LAND USE - ZONING REPORT

BUILDING PERMIT REPORT

Robert C. Heine
12 Gilman Street Walkways + Decks
Sheet #1

Re: Mr. Robert Haines (Stairway request)

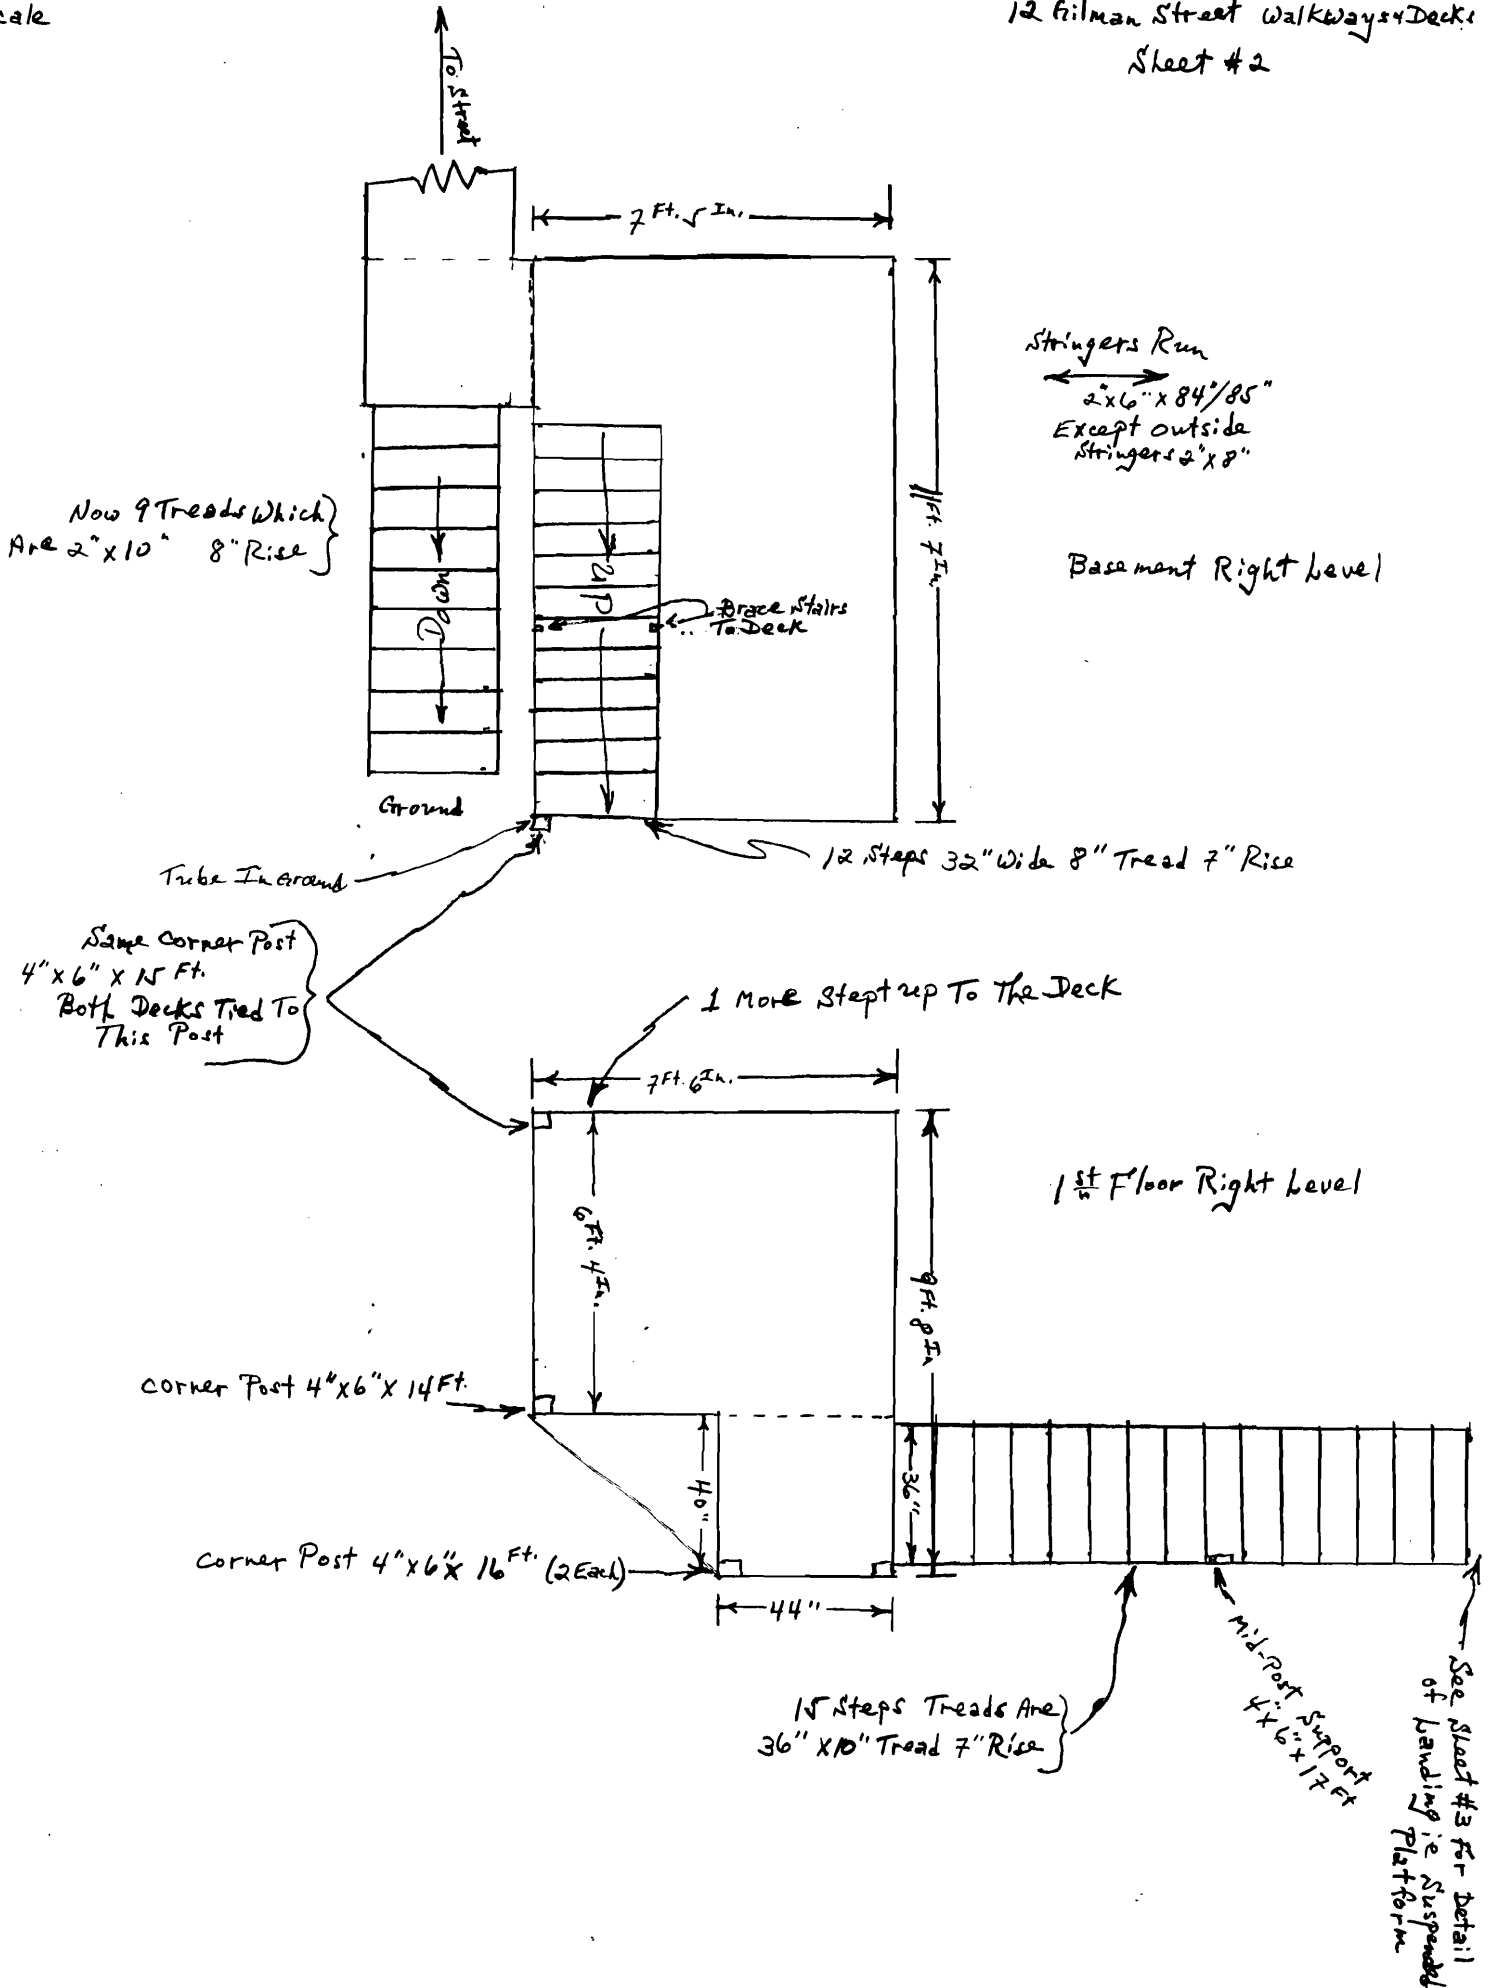
20 Jan 98 - This permit was issued after the fact - This was a replacement therefore some code requirement could not be met. 21/Jan/98 Check stair - Handrail grip too large - openings between stair tread and guard too large.

30. Handrails shall be graspable req. 1 1/2" to 2" in diameter

All Deck Railings Shall Be
2"x4" construction 42" Above
The Deck - Railing walls shall
Be 1/2" or 5/8" Exterior Plywood

All stair Railings shall Be
2"x4" construction 36" To 38"
Inches Above The Stairs.
Railing walls shall Be
1/2" or 5/8" Exterior Plywood

Bottom of Railings shall Be
6" To 8" Above Deck or Stair
Tread Tip. (Snow Removal)

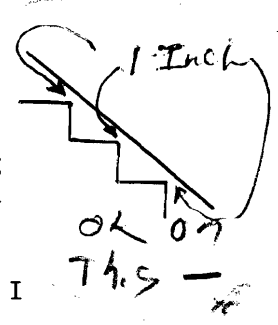
As you are aware there are two issues that have come to light since the construction began (now nearly completed). Item one) the opening size or space at the bottom of the rails on the stairs. The code [which is a code for new construction] states that no opening may be so large that a four inch sphere can pass through that opening. The laws of physics and geometry do not allow, on older rehabilitation, for a maximum four-inch opening. Most older stair tread/rise would leave a five or six inch

Stairs built before permit was issued. Did it review. Final plans of proposed stairs until 1997. Actual look already built stairs.

opening. It is my understanding from our conversation last evening that if the stair sidewalls (rails) are lowered to within one inch of the outside or projecting point of each tread - it will be acceptable to you, and therefore the City.

"The triangular openings formed by the riser, tread and bottom rail at the open side of a stairway shall be of a maximum size such that a sphere 6 inches in diameter cannot pass through the opening". . . I feel that this can be accomplished by dropping the guard. Therefore would not be needed

Request #1 I feel will meet the intent of the code.

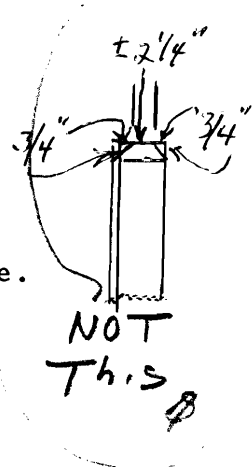
Item two) The hand rails: It has been suggested that I request of you a variance to waive the "1 1/4 to 2 inch round graspable hand rail" in favor of continuing to use the 2 X 4 style of rail that previously existed; see BOCA Code S1022.2.4 as to hand rail requirements. As you are aware this is an outside walk, exposed to the weather; be it sunshine, rain or snow. I suspect that this means of egress has existed since the 1920's. The main stairway ends 16 feet in the air and begins approximately 24 feet in the air and hangs - exposed - off the side of the building. I would think the more solid the better.

The word here is Handrail grip size.

A couple of suggestions have been made to resolve the hand rail issue. One is to drop the plywood one inch below the top 2 X 4. The second is to mitre the 2 X 4 and plywood at a 45 degree angle by approximately 3/4's of an inch on each of the top sides. This would be my preference.

"All stairway handrails shall have a circular cross section with an outside diameter of at least 1 1/4 inches and not greater than 2 inches".

1. "Any other shape with a perimeter dimension of at least 4 inches but not greater than 6 1/4 inches with the largest cross-sectional dimension not exceeding 2 1/4 inches."
2. "Approved rails of equivalent graspability."

Request #2 I feel that Mr. Haines can meet this requirement and should meet this requirement.
